4 May 2018

The General Manager
Northern Beaches Council
1 Park Street
MONA VALE NSW 2103

**PROPOSED DISABLED ACCESS INCLINATOR THRESHOLD STRUCTURE
159 Riverview Road Avalon**

Figure 1—Illustrates the trunk diameter of the tree and its location in relation to the proposed disabled access inclinator threshold structure. Excerpt of SK-01, marked up by C. Mackenzie. Not to scale.

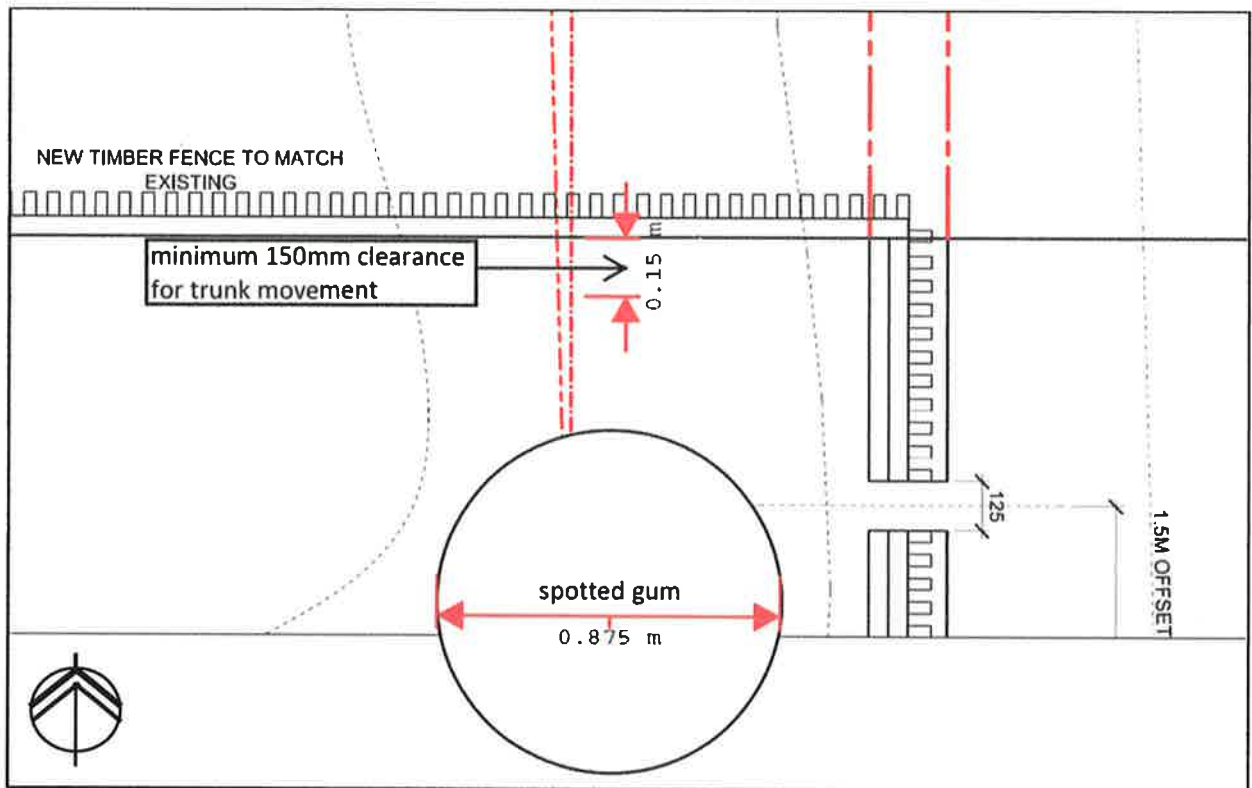
Based on the tree trunk diameter (Figure 1), the tree trunk will be less than 500mm from the closest edge of the proposed disabled access inclinuator threshold structure. Given the trunk tends to have a slight northerly sweep, parts of the tree's trunk are likely be in the vicinity of 300mm from the proposed structure. Even so, the proposed structure will be much greater than 150mm clear of the tree trunk and unlikely to result in any contact damage under extremely strong wind conditions.

Allowing for a generous estimation of annual trunk expansion of 10mm in each direction over twenty-five years, the tree's trunk would be approximately 250mm from the closest edge of the proposed structure.

Figure 2—Illustrates the location of the tree and its lower northern limb (right hand side of tree) over the roof of the proposed disabled access inclinator threshold structure. Excerpt of platform street elevation SK-02, marked up by C. Mackenzie. Not to scale.

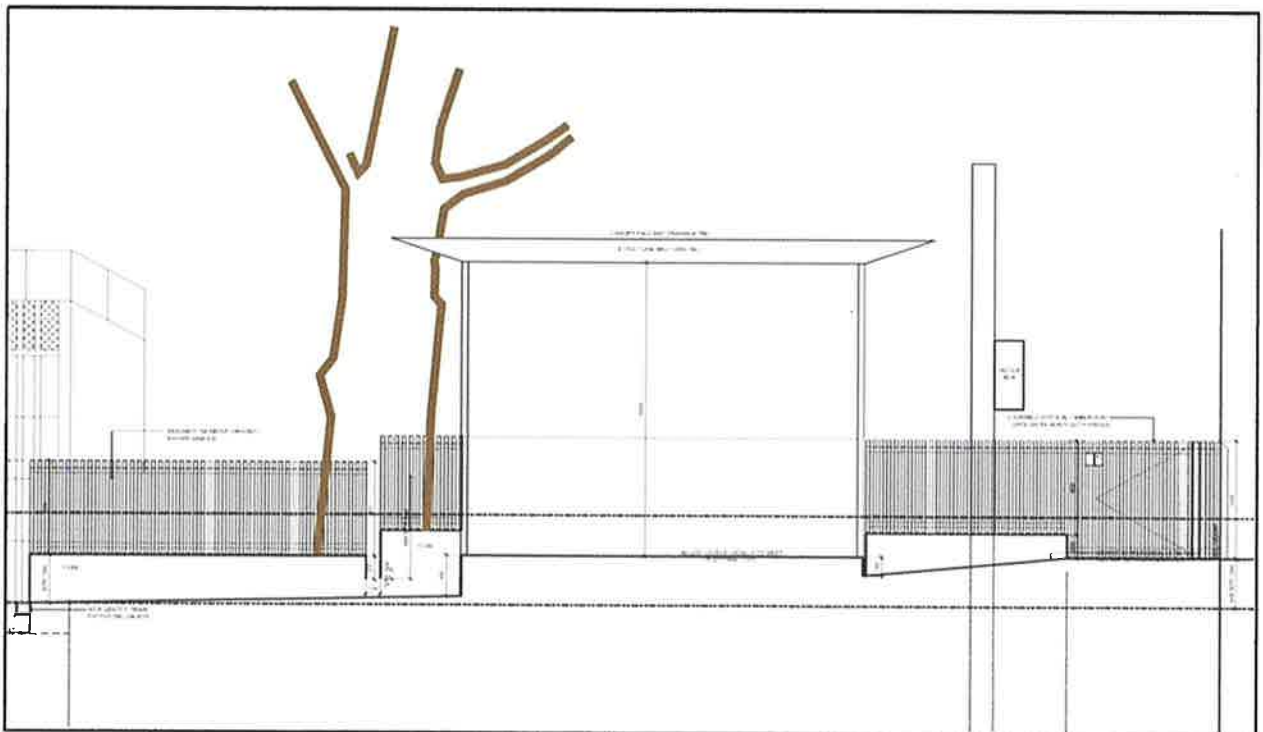
The lowest branch to the north of the tree and where the proposed structure would be constructed, is approximately 3m above the existing concrete fence plinth. The proposed height of the proposed structure from floor to roof would be approximately 2.7m and likely to fit under the limb without any contact occurring. It would require wrapping to protect it during construction. However, if the need arose to remove this limb for clearance, it could be pruned without any adverse impact on the tree's viability.

- The northern limb of the tree shall be wrapped with carpet or layers of hessian thick enough to protect the limb from contact damage during construction.

Figure 3

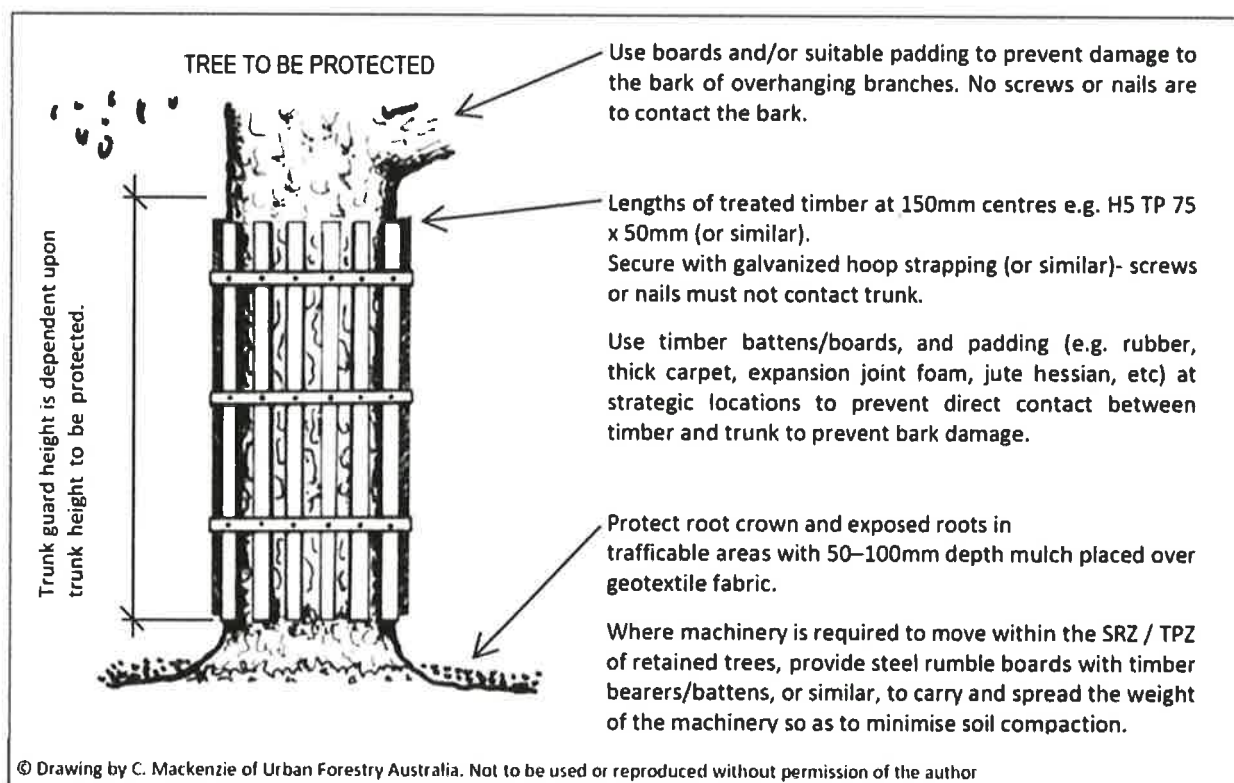
- The trunk of the tree and any exposed root buttress or roots shall be protected for the entire works period. A trunk guard is to be provided that protects the entire trunk from ground level to a distance at least 3m above the existing public road level (Figure 3).
